IWUIC

2021 GROUP A PUBLIC COMMENT AGENDA

SEPTEMBER 21 - 28, 2021
DAVID L. LAWRENCE CONVENTION CENTER
PITTSBURGH, PA

Figure 1. Ember accumulation at the intersection of exterior walls and ground [2].

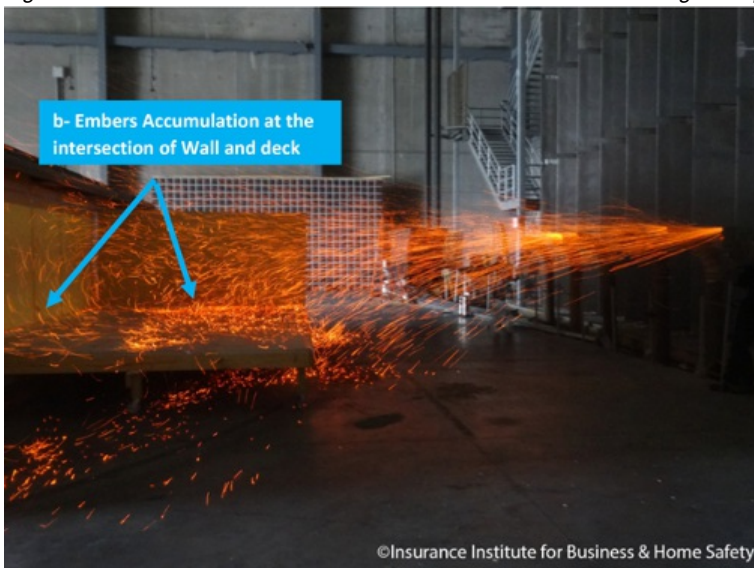
Tests performed at the IBHS Research Center show the importance of preventing ignition of the siding due to wind-blown embers. Figures 1 and 2 depict a full-scale experiment on exterior walls and an attached deck assembly exposed to wind-blown embers. According to these studies, wind-flow will trap the embers and combustible debris at the base of the exterior walls and at the base of other horizontal surfaces such as attached decks [1,2]. The figures clearly show the ember accumulation at these locations. Protecting the exterior walls at these locations with noncombustible materials will improve the fire-performance of these walls and break the fuel load path toward the main structural elements.

Figure 4. Exterior wall exposed to a small fire with 6-in noncombustible vertical clearance.

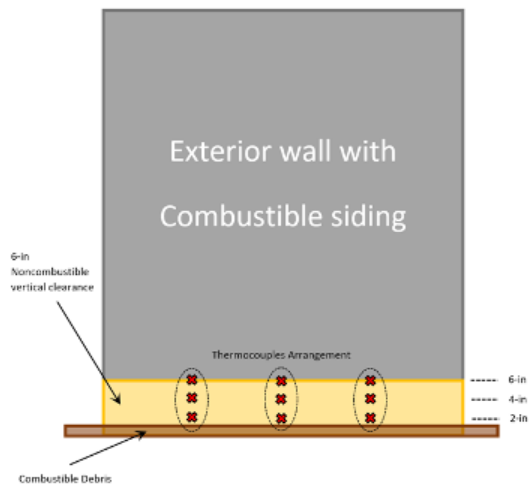
In the second experiment, an exterior wall assembly with combustible debris approximately 1 inch in thickness at the base was exposed to a small fire. During this test, the heat distribution along the walls was recorded by 18 thermocouples and an infrared camera. Thermocouples were placed at 2, 4, and 6 inches vertically from the ground level to record the heat distribution along the wall. Figures 4 and 5 depict the exterior wall assembly during the fire test and identifies the thermocouple arrangement.

Figure 6. Heat distribution at 2 inches above ground level with the base of the exterior wall exposed to the small fire.

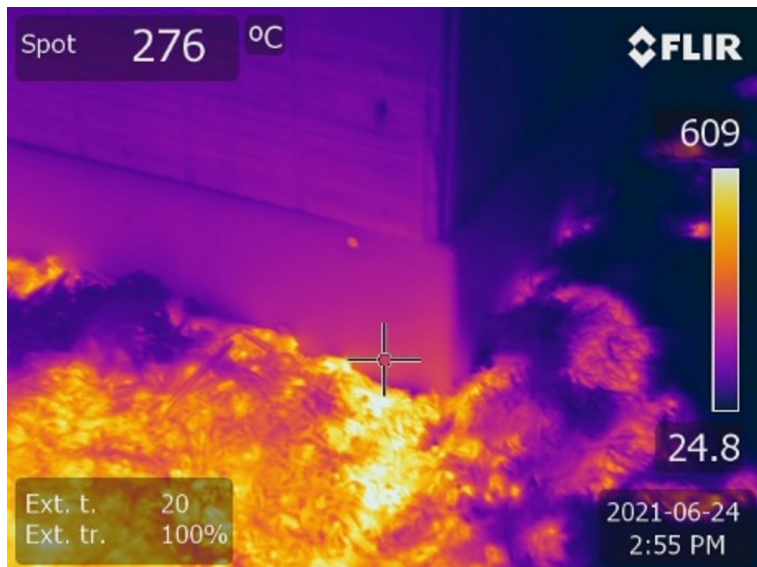
The heat distribution recorded along the wall confirms that even small fires can easily ignite combustible siding at 2 and 4 inches from the ground level. The photograph in Figure 6 was taken with an infrared camera and shows heat distribution at the base of the wall at 2 inches from the ground level. The measured temperature at this level was 276 °C which is high enough to ignite the plywood siding panel.

Figure 7. Heat distribution at 6 inches above ground level with the base of the exterior wall exposed to the small fire.

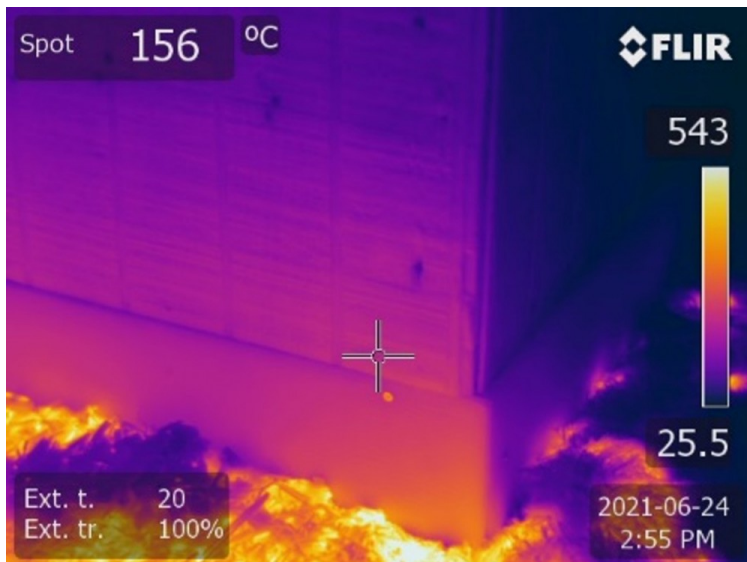
The photograph in Figure 7 shows heat distribution at the base of the wall at 6 inches from the ground level. The measured temperature at 6 inches from the ground level was significantly lower than 2- and 4-inch heights. It's important to note that the combustible siding, which was separated from the ground by 6 inches of noncombustible material, did not ignite during the test.
